ADDENDUM NO. 3:

Date: February 10, 2026
 Project: Verbena HS Gym
 DCM# 2025629
 WSM# 25-032

Owner: Chilton County Board of Education
 Architect: Ward Scott Morris Architecture, Inc.

S000

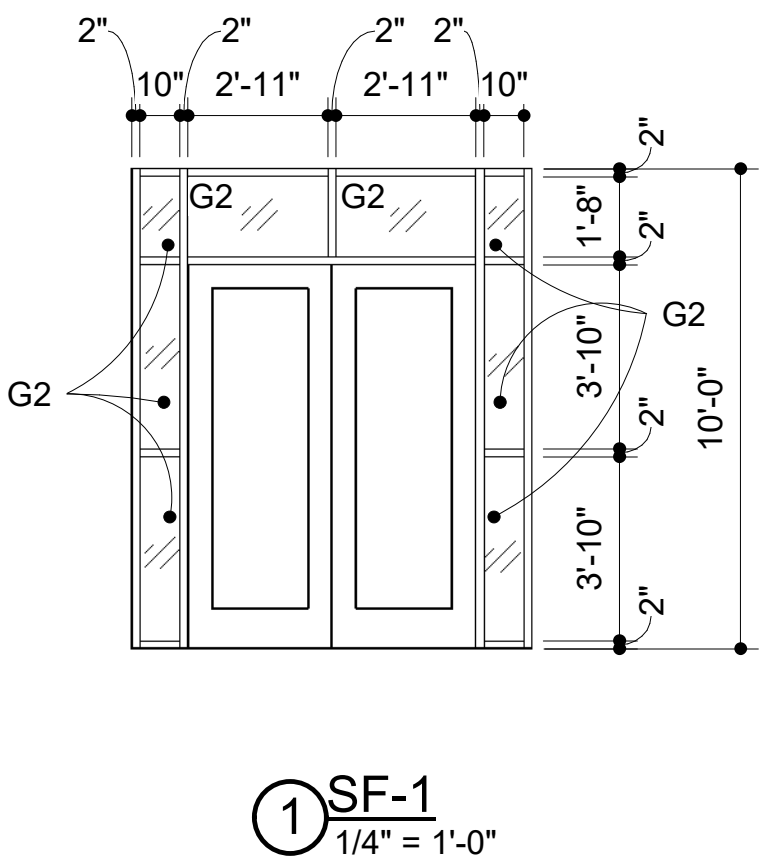
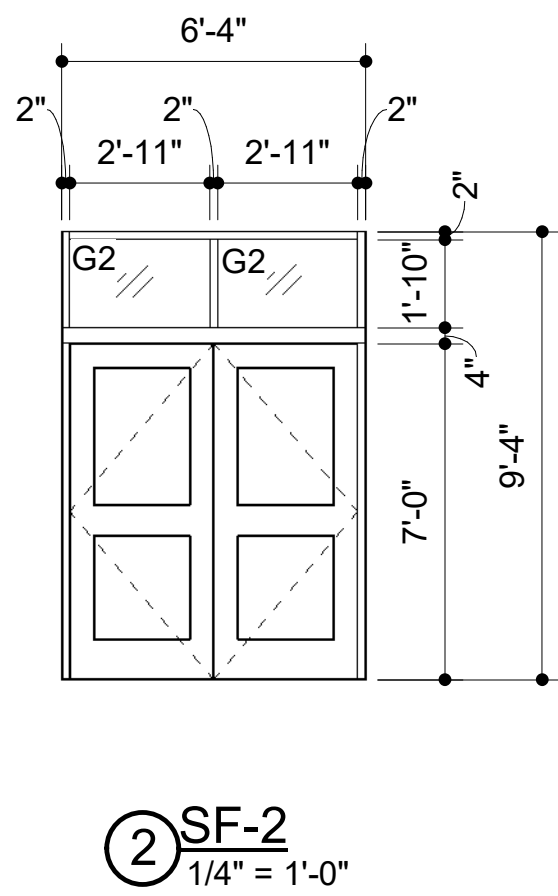
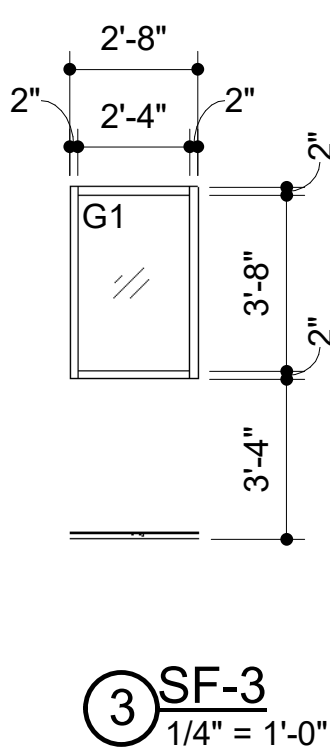
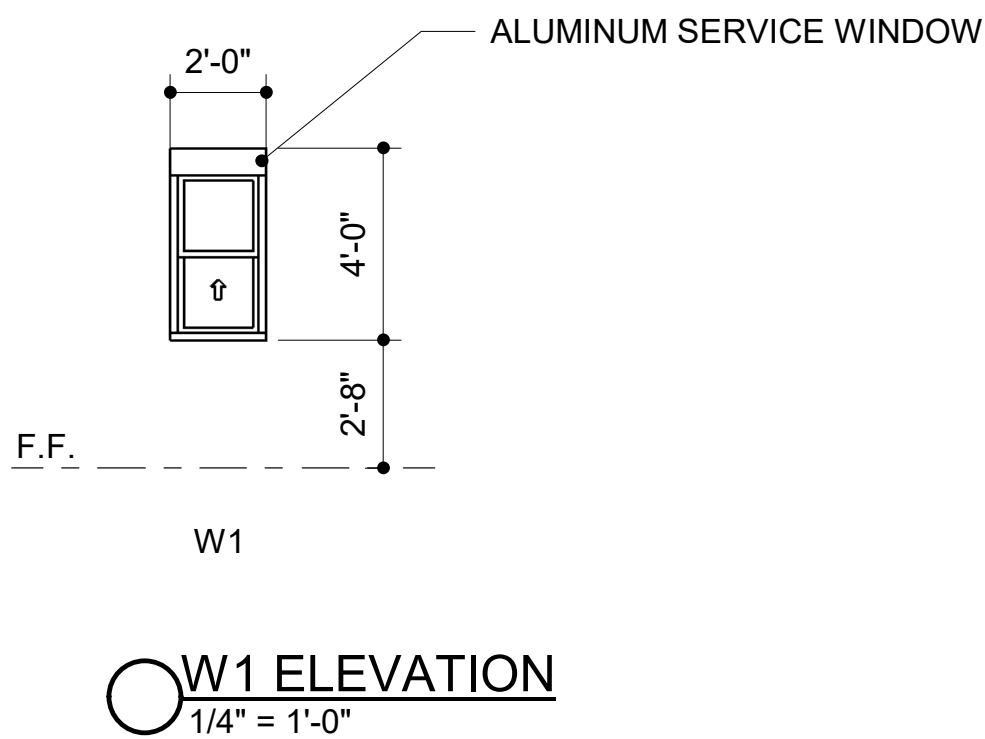
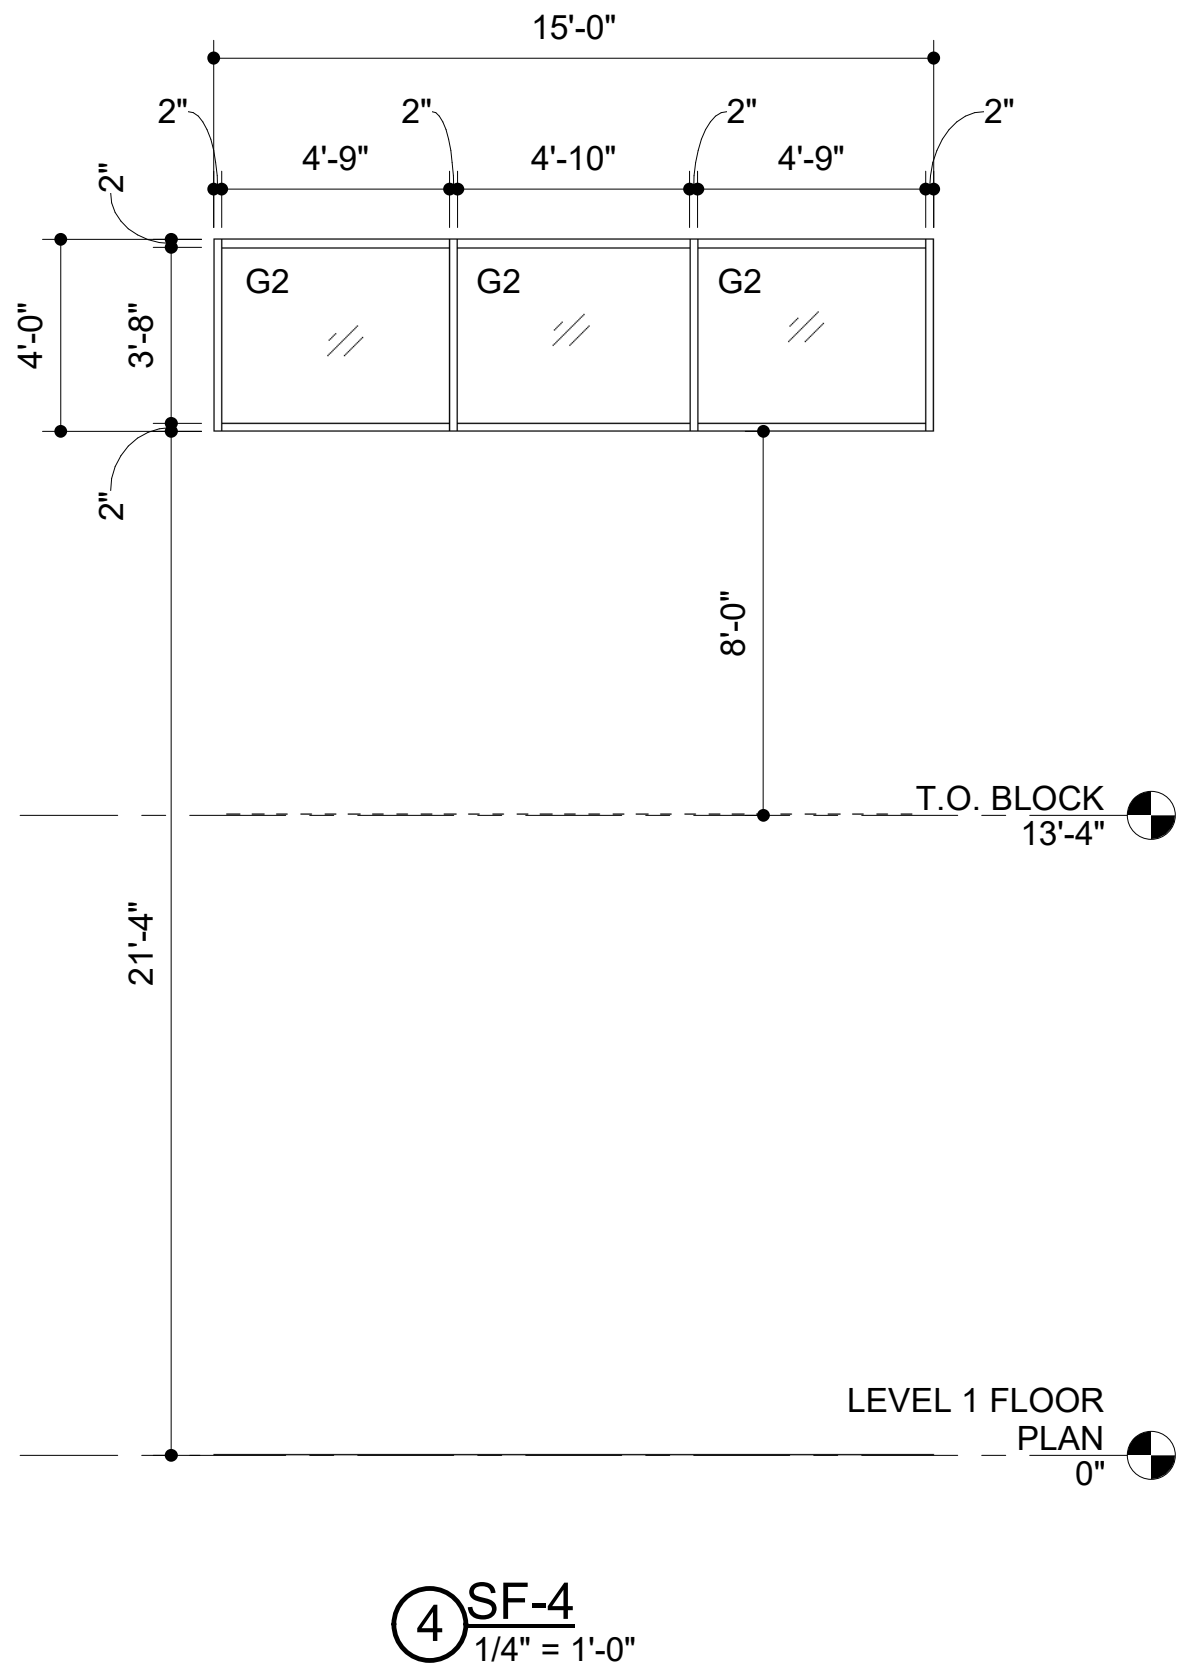
- A. Structural Sheets S000, S100, S500; Refer to attached revised drawings for wall relocation between Rooms #1104 and #1105.
- B. Sheets A002; Refer to attached revised drawing for door and glazing changes.
- C. Sheets A101, A111 and A301; Refer to attached revised drawings for wall relocation and door added between Rooms #1104 and #1105.
- D. Sheet A103; Kitchen Equipment Schedule; change R/F model numbers to TS-24F-FLX-HC, TS-23F-FLX-HC, all stainless-steel exterior.
- E. Sheet A103 and A111; Addendum No. 1 item 1.3.H; R/F-2; change this model number to TS-49FG-FLX-HC-FGD01, all stainless-steel exterior.
